MSEX2012A-03

S E R V I C E N O T E

MSEX2012A – Oscilloscope, Mixed Signal, 2+8 Channel,
100MHz

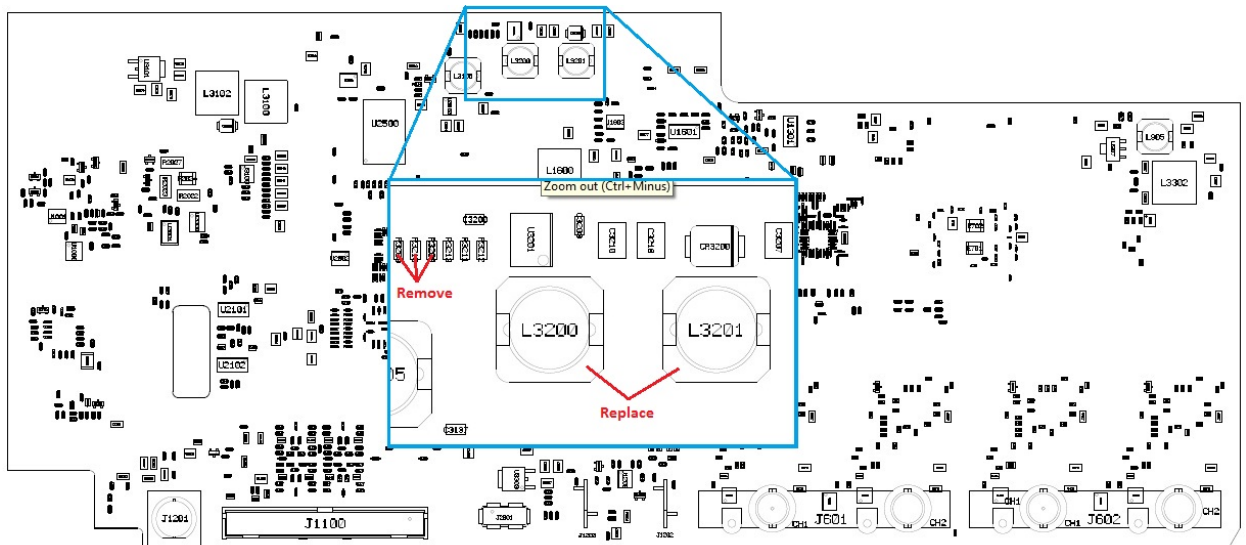
With the oscilloscope power turned on and while under normal operation, the unit emits a hissing noise.

2. As the picture indicates, remove the three resistors (0699-7209, 1 Ohm) located at R3208, R3209, and R3210. They are not to be replaced.
3. Remove as well the two inductors (9140-6474, 100uH) located at L3200 and L3201 and replace them with inductors with part number 9140-6151 (68 uH).
4. Re-assemble to the point where the unit could be powered up to verify that the hissing is indeed gone. If the hissing is not gone, please, check modifications.
5. When the hissing is gone, put oscilloscope back together.
